# HISTORIC AND DESIGN REVIEW COMMISSION

January 17, 2018

**HDRC CASE NO:** 2018-026  
**ADDRESS:** 1830 N PINE ST  
**LEGAL DESCRIPTION:** NCB 992 BLK 1 LOT 21  
**ZONING:** R-6, H  
**CITY COUNCIL DIST.:** 2  
**DISTRICT:** Government Hill Historic District  
**APPLICANT:** Christopher Gill/CGRE LTD CO  
**OWNER:** Christopher Gill/CGRE LTD CO  
**TYPE OF WORK:** Installation of windows, amendments to previously approved rear addition, door installation  
**APPLICATION RECEIVED:** January 04, 2018  
**60-DAY REVIEW:** March 05, 2018  
**REQUEST:**

The applicant is requesting a Certificate of Appropriateness for approval to:

West Elevation (Front)

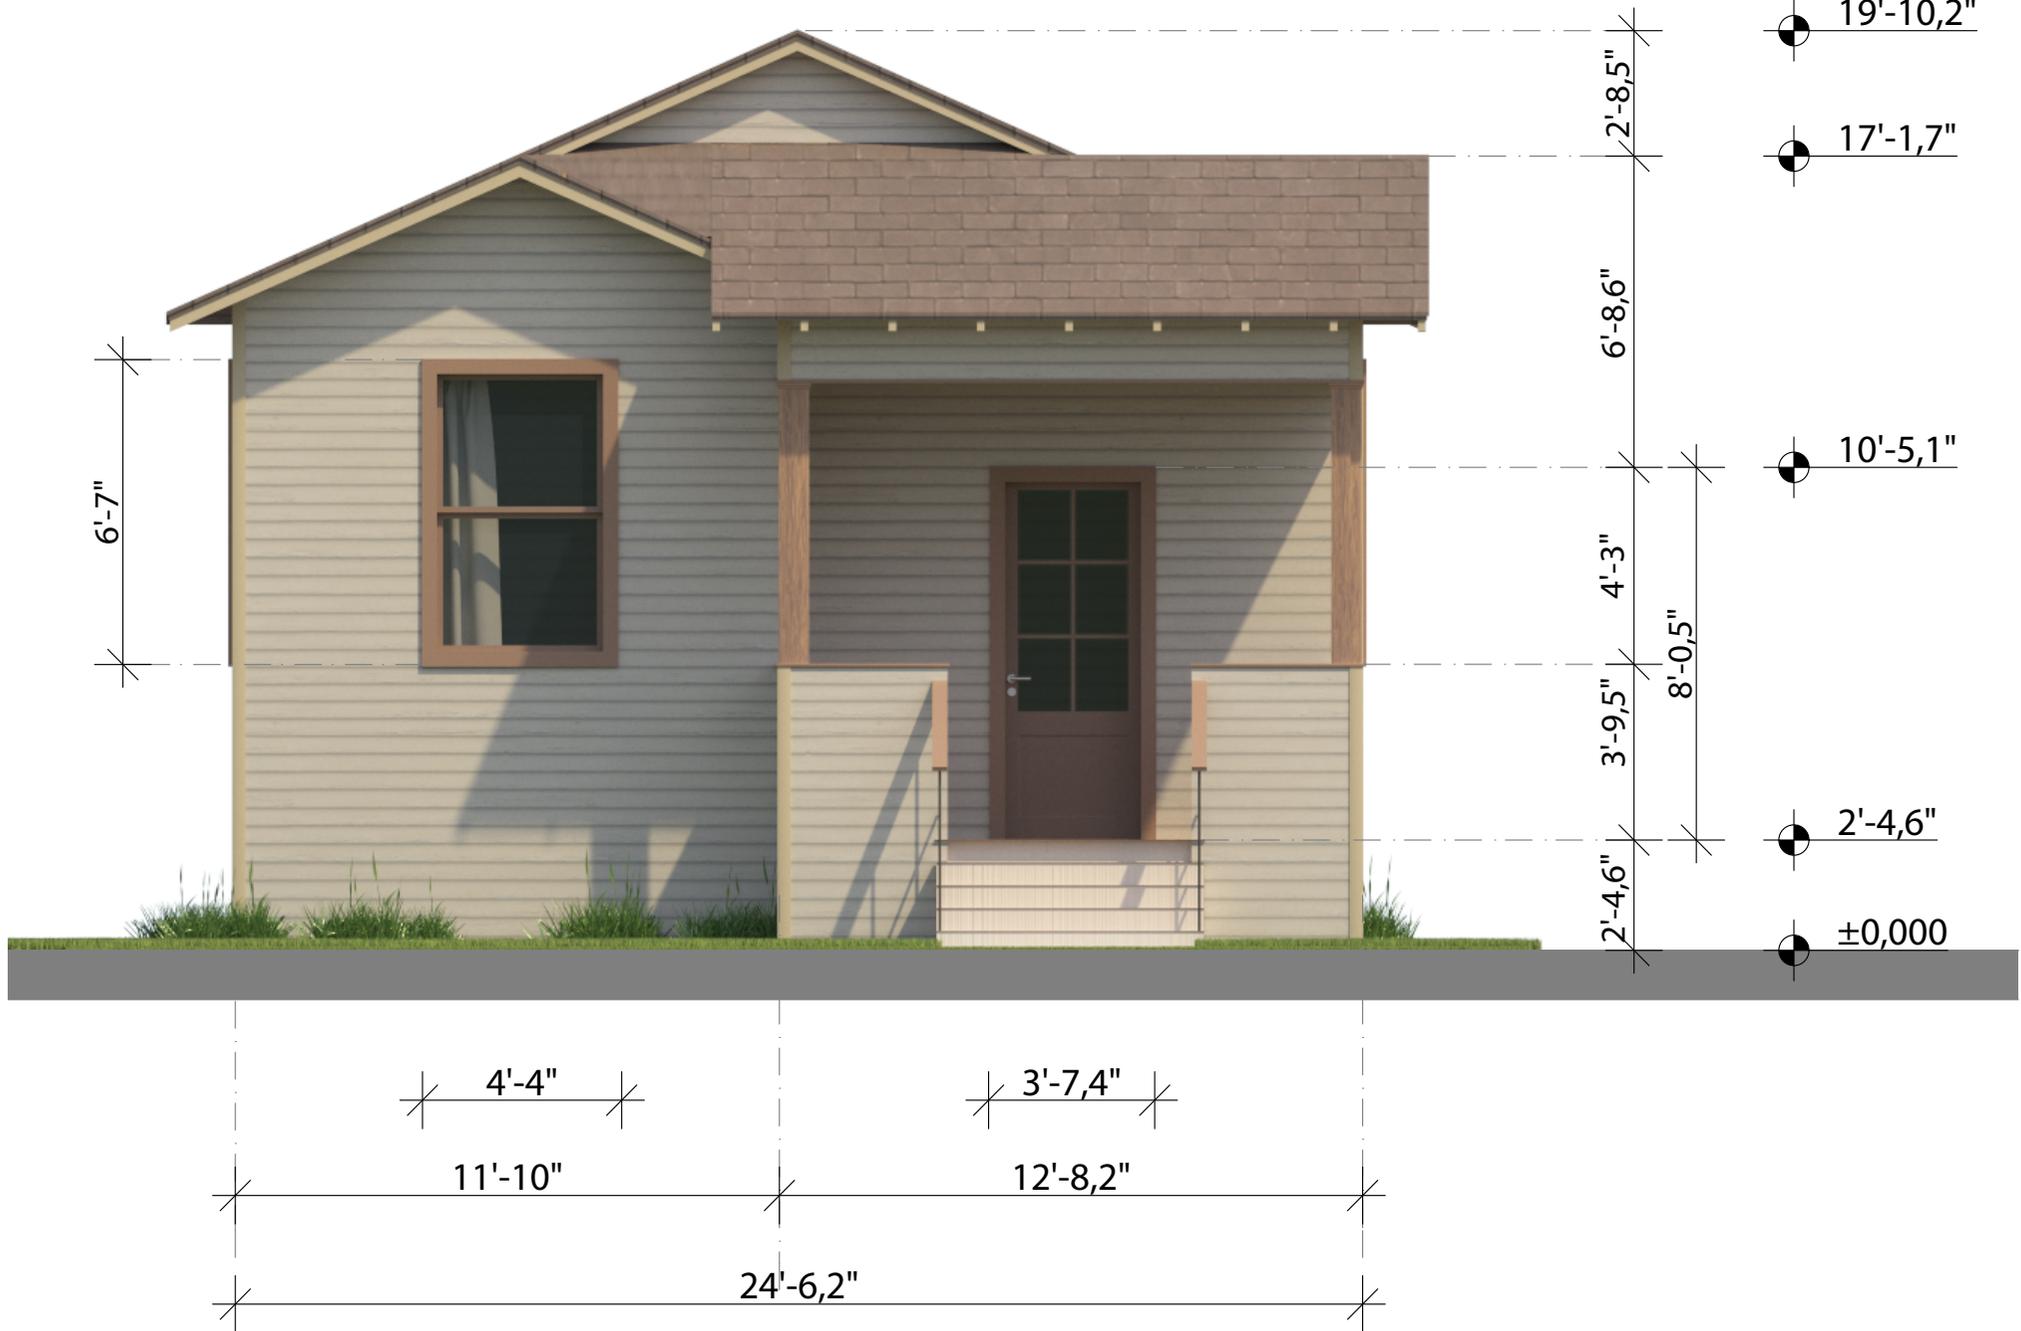
- c. **WINDOWS** – The applicant has installed two windows into the historic structure that do not feature appropriate sashes, meeting rails, frames or profiles. The windows are composed of 2x4 dimensional lumber, wood trim and glass. The applicant has proposed to retain these two elements. Staff finds the installed elements to be inappropriate and inconsistent with the Guidelines. Staff finds that salvaged wood windows that feature an appropriate profile and operable sashes should be installed.

- e. **FRONT DOOR & ADDRESS NUMBERS** – The applicant has installed a front door and address numbers without approval. While the address numbers are atypical with those found historically in the district, staff finds the installation of both element to be appropriate.

1. Staff recommends approval of the rear addition as constructed based on finding d.
2. Staff does not recommend approval of the installed inappropriate windows based on finding c. Staff recommends that salvaged wood windows that feature an appropriate profile and operable sashes should be installed.
3. Staff recommends approval of the installed door and address numbers based on finding e.

East Elevation (Back)

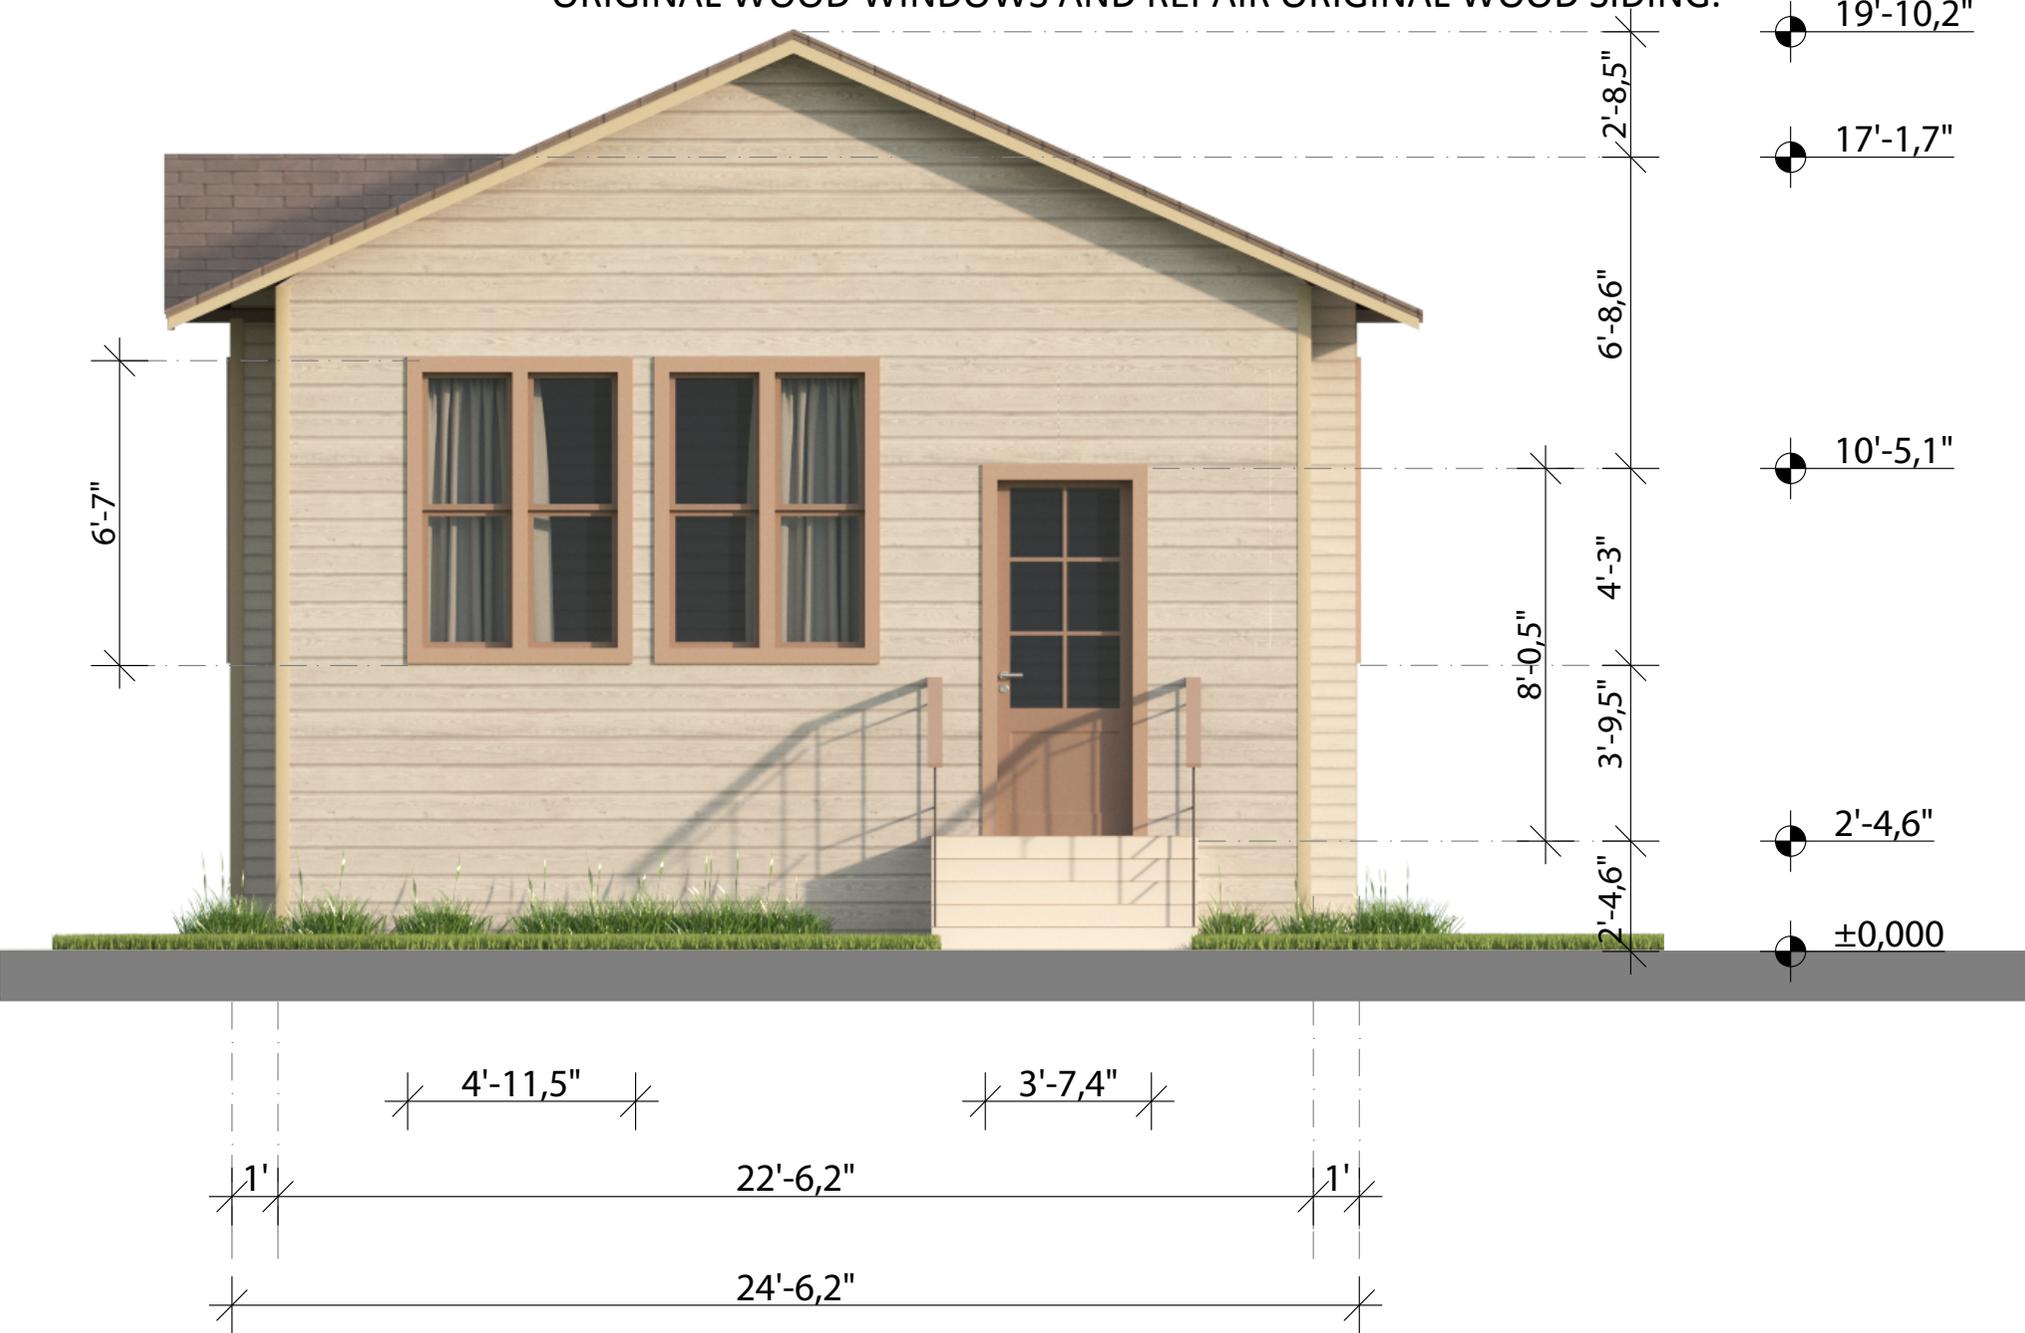
- d. **REAR ADDITION** – The rear addition was constructed inconsistently with the previously approved design. Window and door openings, roof form and a hot water heater closet have been identified as being inconsistent with the previously approved design. While inconsistent with the previously approved design, staff finds these elements to be generally appropriate.
